**DEPARTMENT OF TRANSPORTATION
STATE OF GEORGIA**

SUBJECT PROJECT CONCEPT REPORT APPROVAL

SUBJECT: CONCEPT REPORT

SR 155/CANDLER ROAD ARTERIAL ENHANCEMENTS
(Phase I - Intersection Improvements Candler Road @ Glenwood Road)

PIER DETAIL
Not To Scale

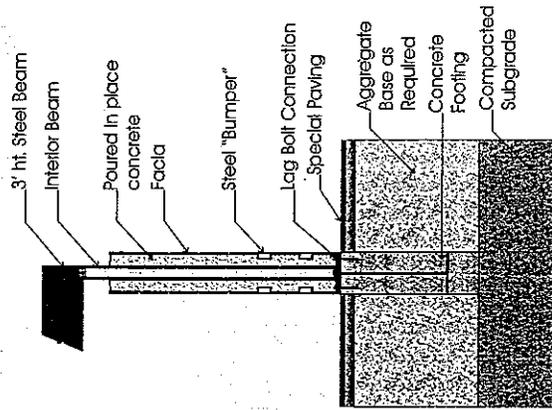
- C. DeKalb County Planning noted that architectural identity piers are referenced in the Concept Report but are not shown. RAA stated that these piers have been developed but were not included in the report for the sake of simplifying the Concept Report. These drawings can be provided to DeKalb County Planning.

SIGNALIZATION STRUCTURE DETAIL
Not To Scale

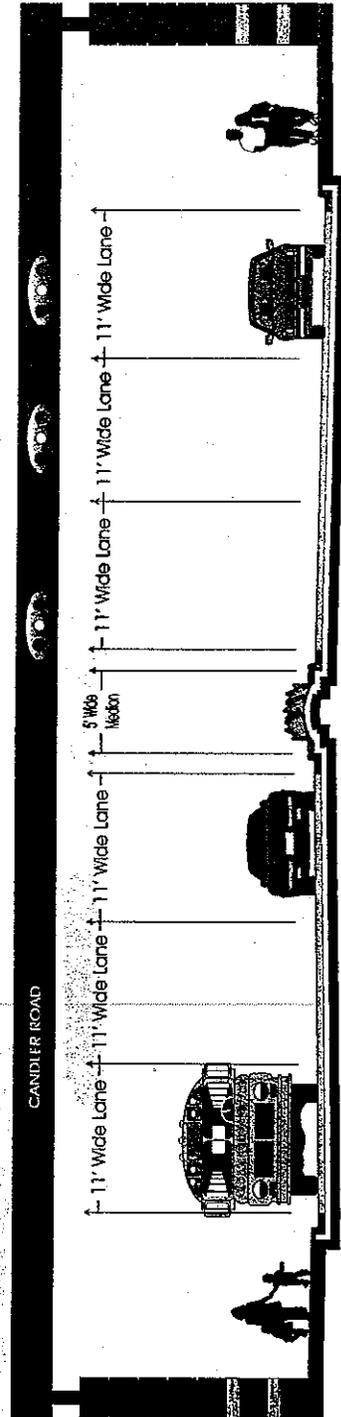
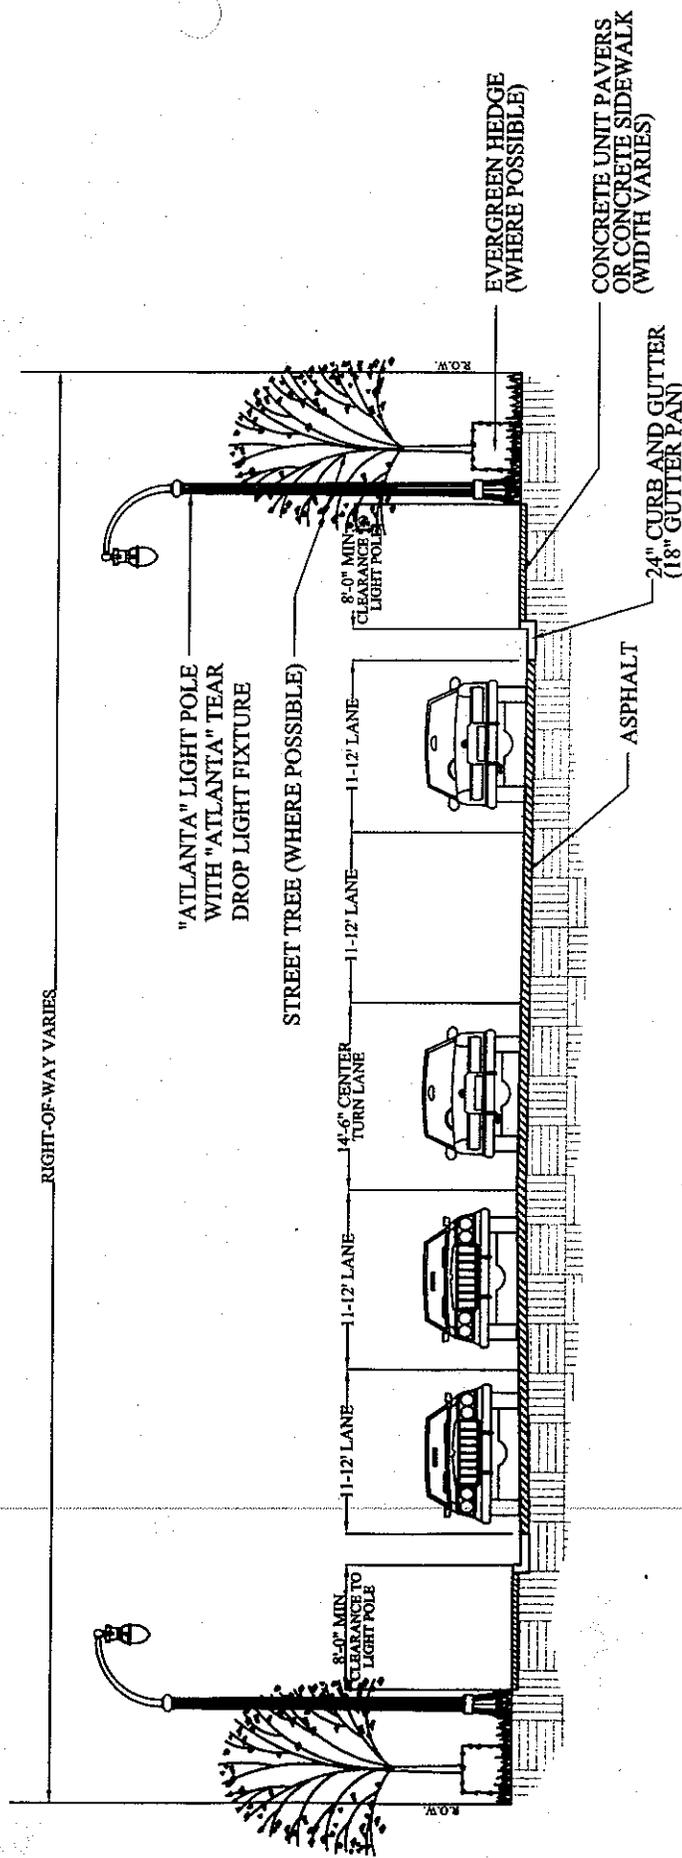
- D. The signal heads on the proposed signalization structure may require vertical orientation. The signal heads are currently shown with horizontal orientation. List vertical orientation as an option for the final Concept Report submittal. GDOT will debate which orientation to follow for detailed design of the structure.

- E. The columns for the proposed signalization structure need to be of such a design as to prevent vandalism. In particular, people should not be capable of climbing the columns.
